SUBJECT: SEP TOPICS VI-2.D AND VI-3 EVALUATION REPORT
FOR MILLSTONE NUCLEAR POWER STATION, UNIT 1

SAFETY EVALUATION REPORT
ON
CONTAINMENT PRESSURE AND
HEAT REMOVAL CAPABILITY
SEP TOPIC VI-3
AND
MASS AND ENERGY RELEASE
FOR POSSIBLE PIPE BREAK
INSIDE CONTAINMENT,
SEP TOPIC VI-2.0
FOR THE
MILLSTONE 1 NUCLEAR POWER PLANT

DOCKET NO. 50-245

Figure 1. Millstone 1 Containment Pressure Response to a Double-Ended-Gullotine Recirculation Line Break

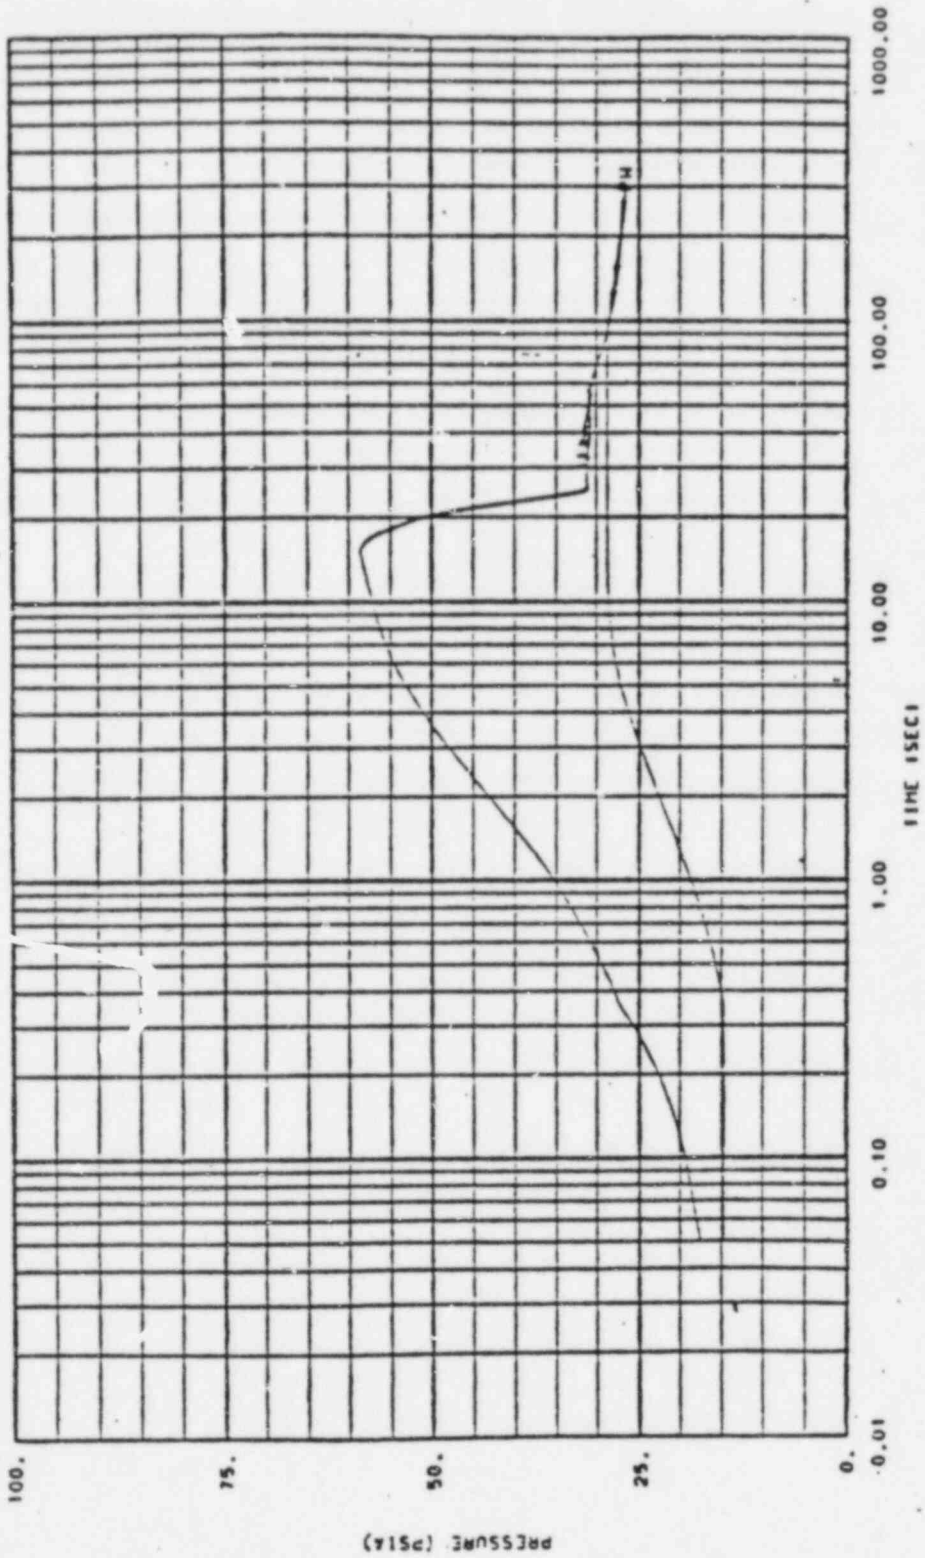
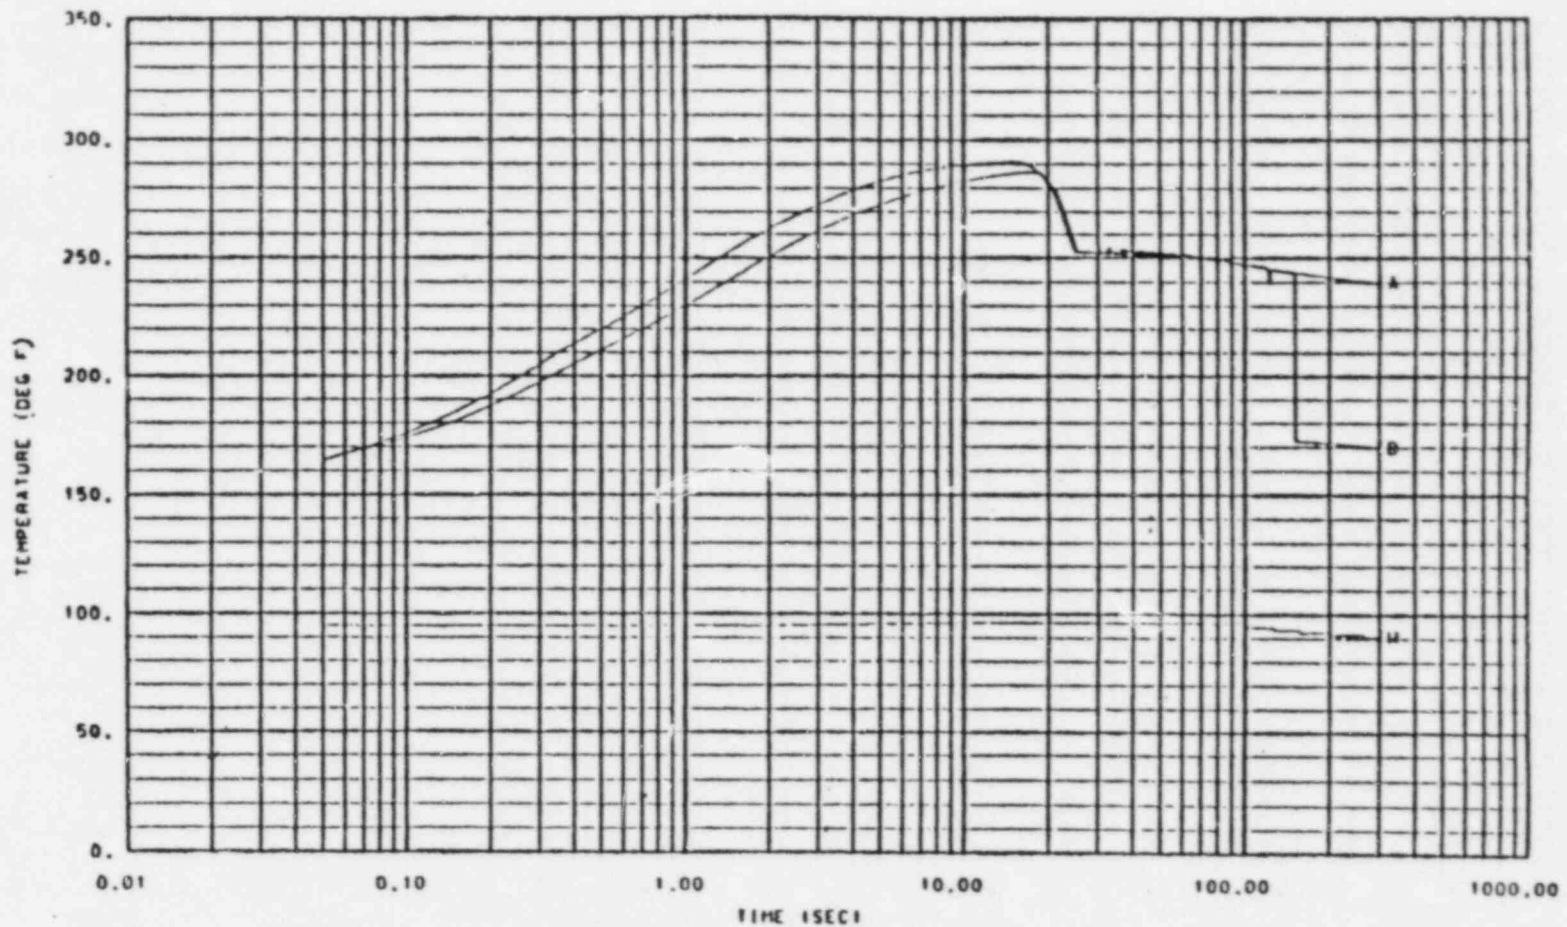
The containment pressure and temperature responses to a recirculation line break are shown in Figures 1 and 2. The calculated transient reflects a peak post-accident containment drywell pressure of 44 psig and a temperature of 291^oF. The peak containment wetwell pressure and temperature are 14 psig and 144^oF. The containment design pressure for the drywell and the wetwell is 62 psig. There is, therefore, a substantial margin between the peak calculated pressure and the containment design pressure.

Figure 3. Mass Flux vs. Total Depleted Energy, 0.75 ft² and 0.10 ft² MSLB

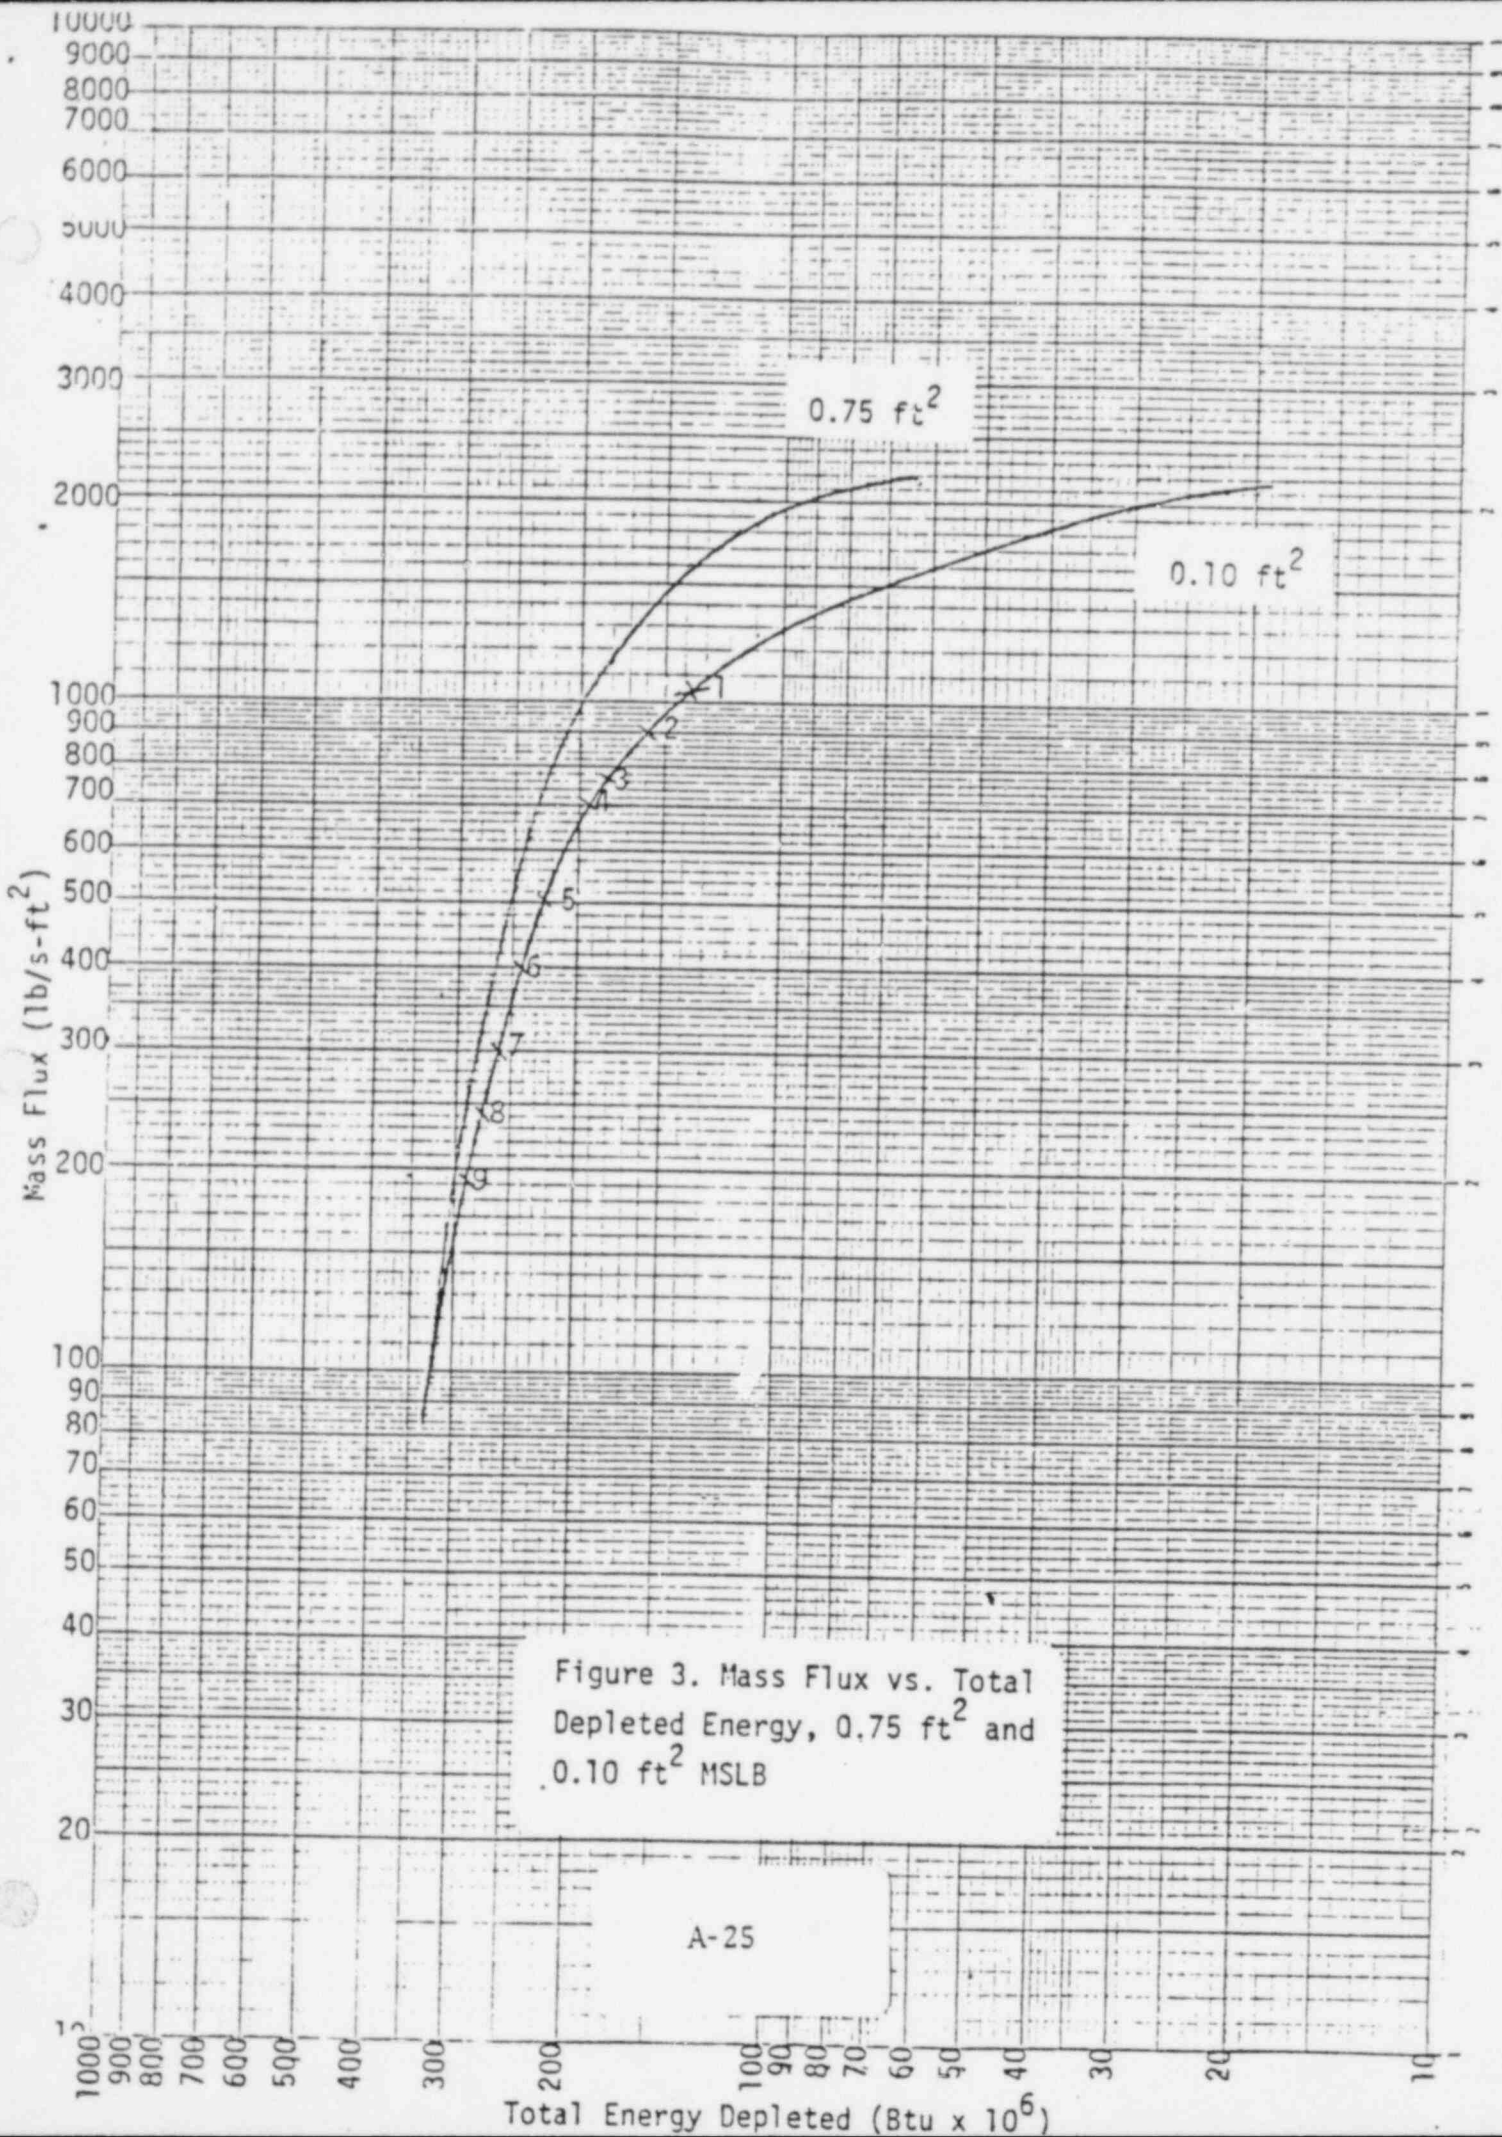
First the curve was plotted, in Figure 3, using the revised data for the 0.75 ft² MSLB given in Table 5. Then the data was plotted for the 0.10 ft² MSLB through 611.4 seconds and extended graphically so that it asymptotically approached the curve generated from the 0.75 ft² break. This was done as an assumption that both breaks would converge. From this curve, representative points were selected and from them the values of mass flow rate and time were determined. The revised blowdown is shown in Figure 4 and compared with the original. For example, point 1 on Figure 3 indicates that the mass flux equals 1031 lb/ft² seconds. Thus $\dot{m} = 103 \text{ lb/sec}$.

Figure 4. Revised Blowdown Data for the 0.10 ft² HSLB

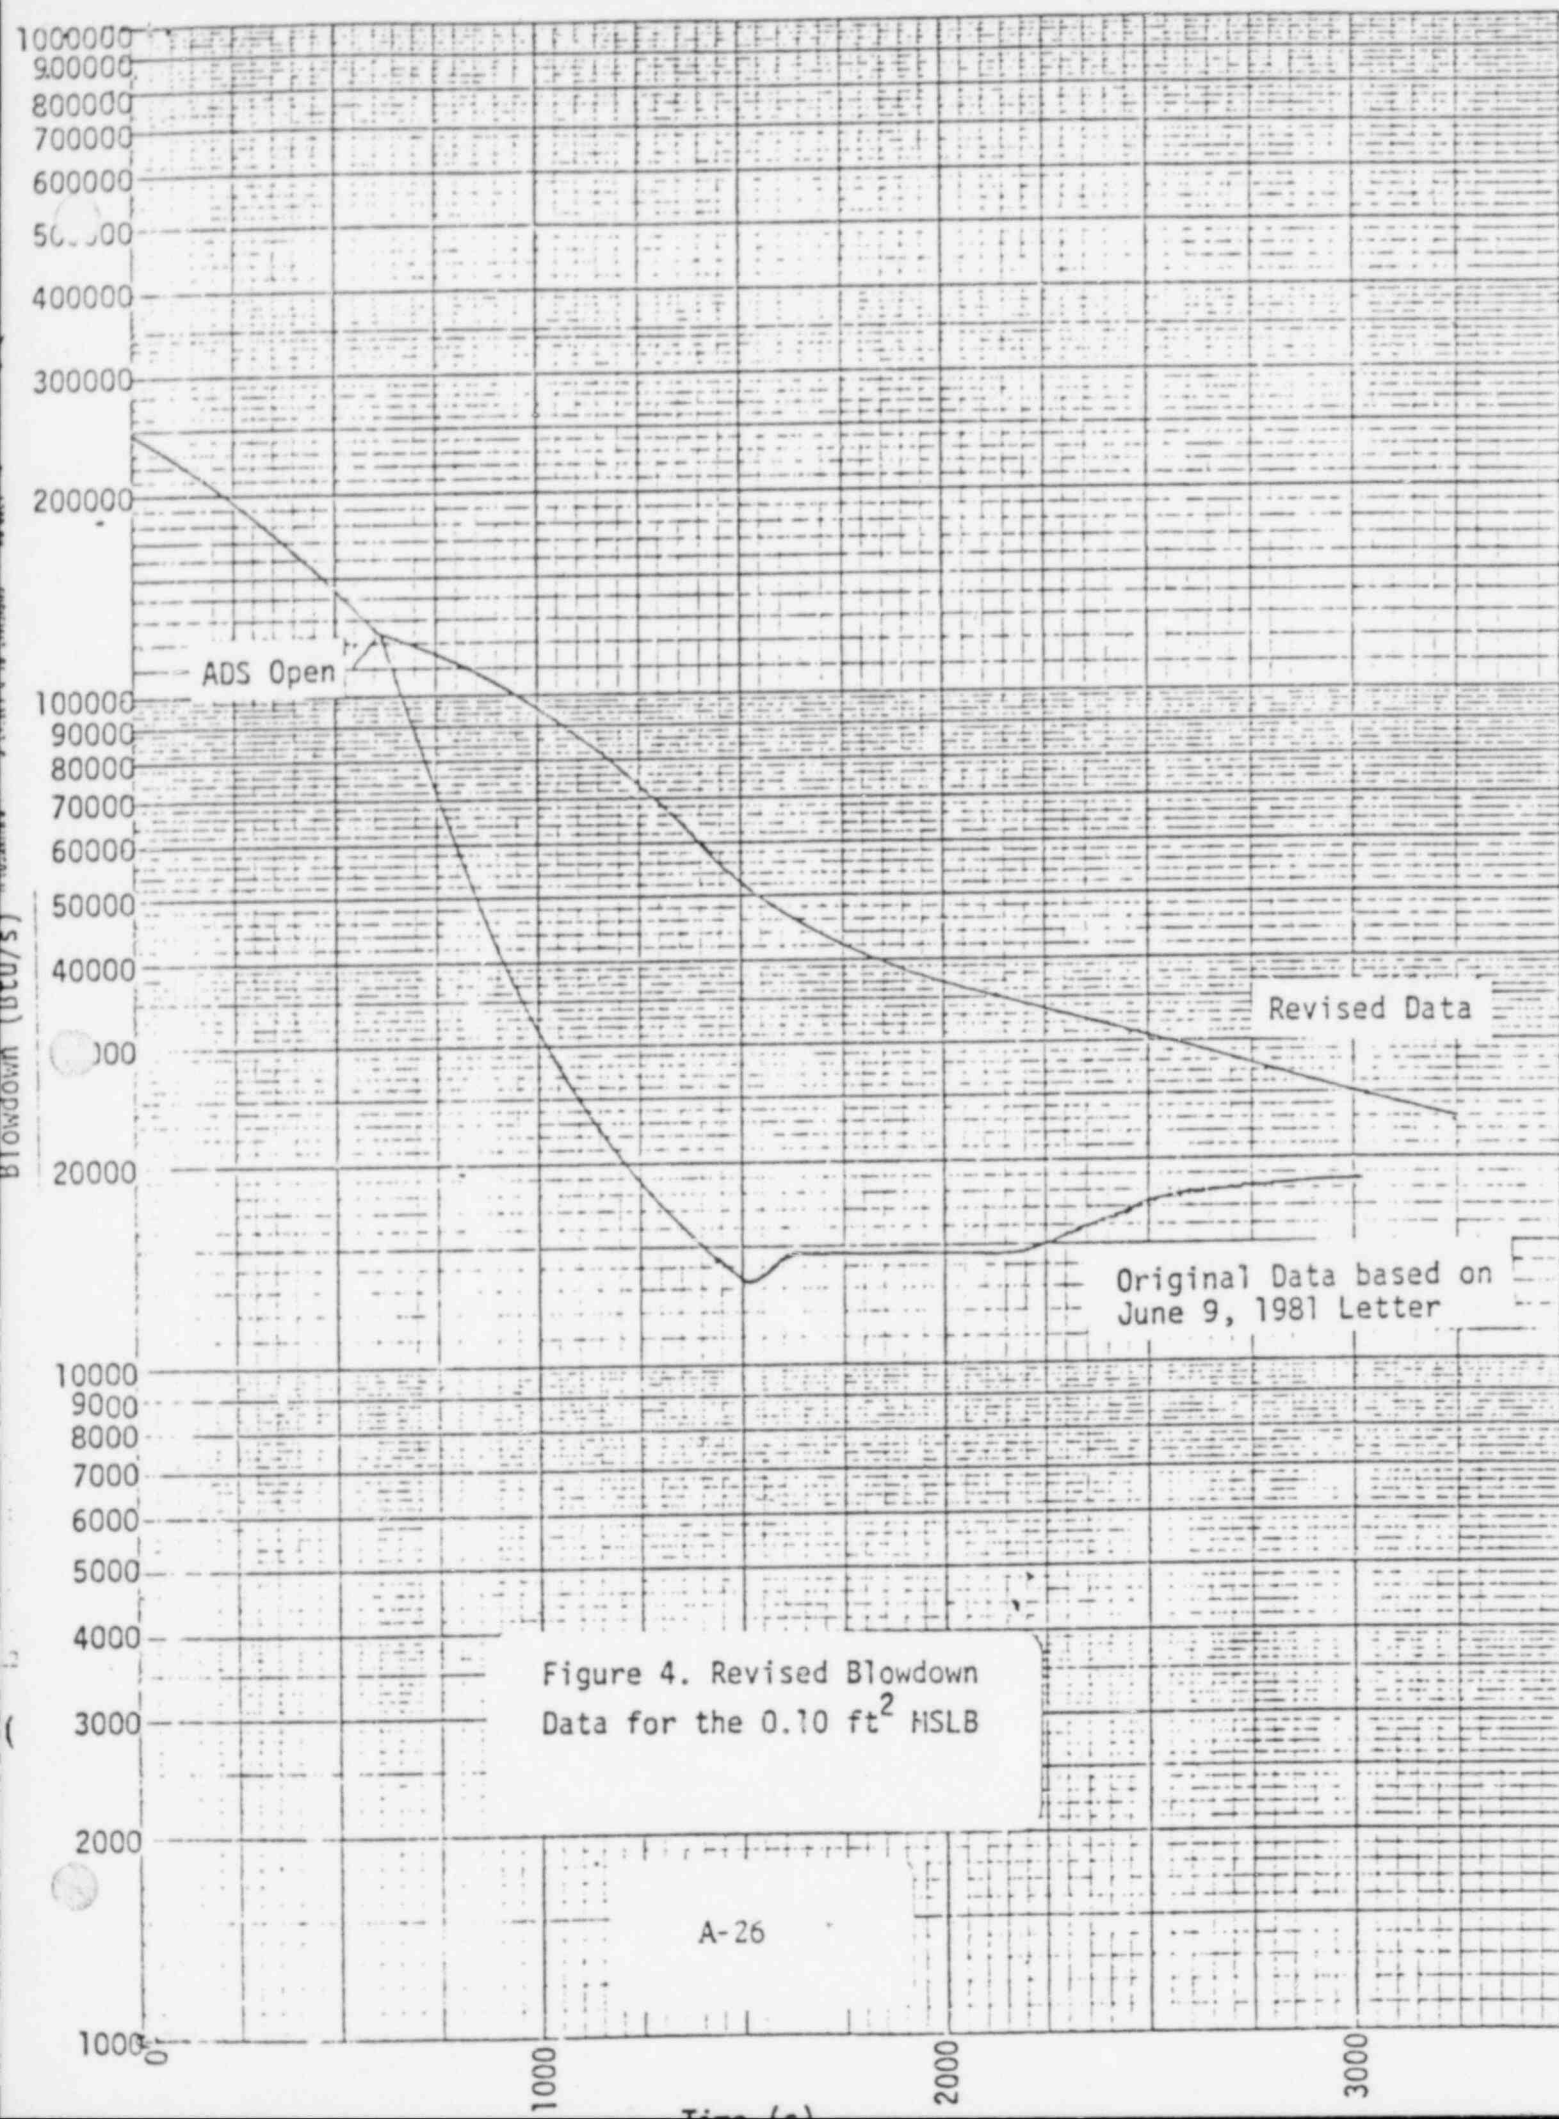
Table 6 gives the revised blowdown data and Figure 4 shows the revised blowdown curve.

As with the 0.75 ft² break, the effects on containment temperature of this modifications compared to the utility deck is marginal. The peak temperature is the same for both sets of data.
